## Pending Amendments to Clauses in the Griffith University Design Guidelines & Procedures Version 18

### Edition 18.3

**Diagram 18.i**

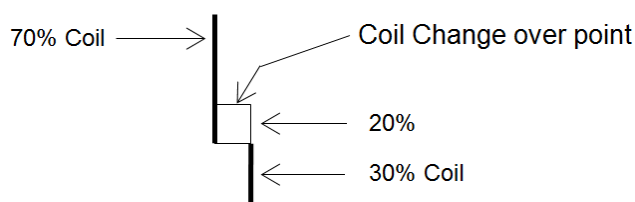
- If the load requires less than 50% of the cooling capacity of the large coil and the small coil is closed down, then the small coil shall be reactivated and the CW flow to both coils modulated to decrease the capacity of the large coil and increase the capacity of the small coil

- When the load has once again exceeded the 100% cooling capacity of the small coil, then the CW flow control outlined above will commence a new cycle.

The object of this operating strategy is to achieve the maximum amount of cooling required for the minimum amount of the coil cooling capacity available. This will also de-humidify the air and provide the potential to maintain comfort levels while allowing the temperature set point to be raised, with a consequent saving in energy.

**Diagram 18.ii**

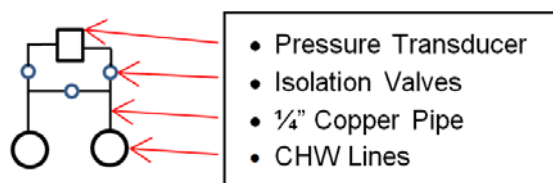
*Insert the following at the end of the existing second paragraph;*

The VSD of any secondary chilled water pump shall be controlled by a pressure transducer located in an easily accessible location at approximately two thirds (2/3) of the distance along the index chilled water pipe run. The pressure transducer pipework shall be configured as shown in the following Diagram 18.ii.

**Diagram 18.iii**

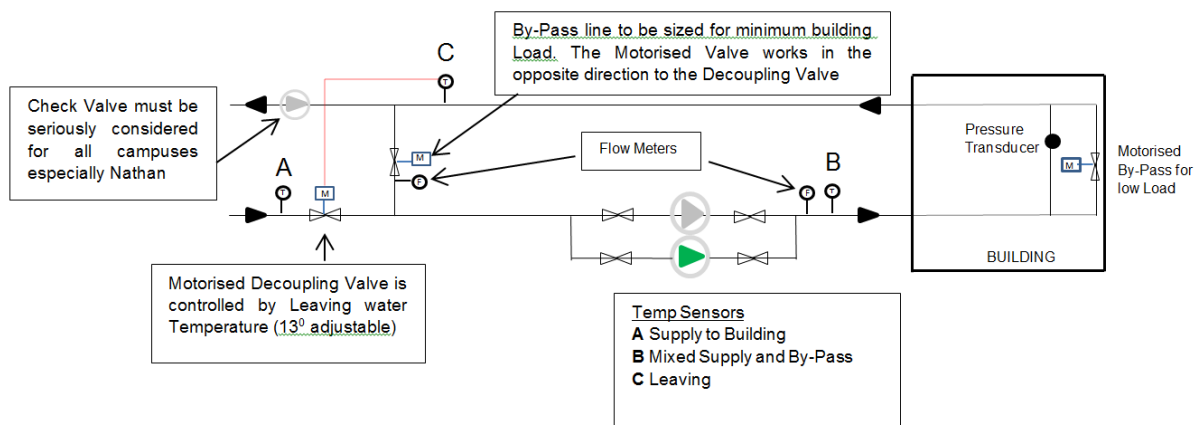
*Insert following new paragraph between the existing fourth and fifth paragraphs;*

**Secondary Chilled Water Pipework Layout** – The supply and return pipework within a building, shall incorporate the secondary pipework and control/monitoring valves and equipment as shown on the following Diagram 18.iii to maintain consistent water flows and temperature control throughout the building pipework system.
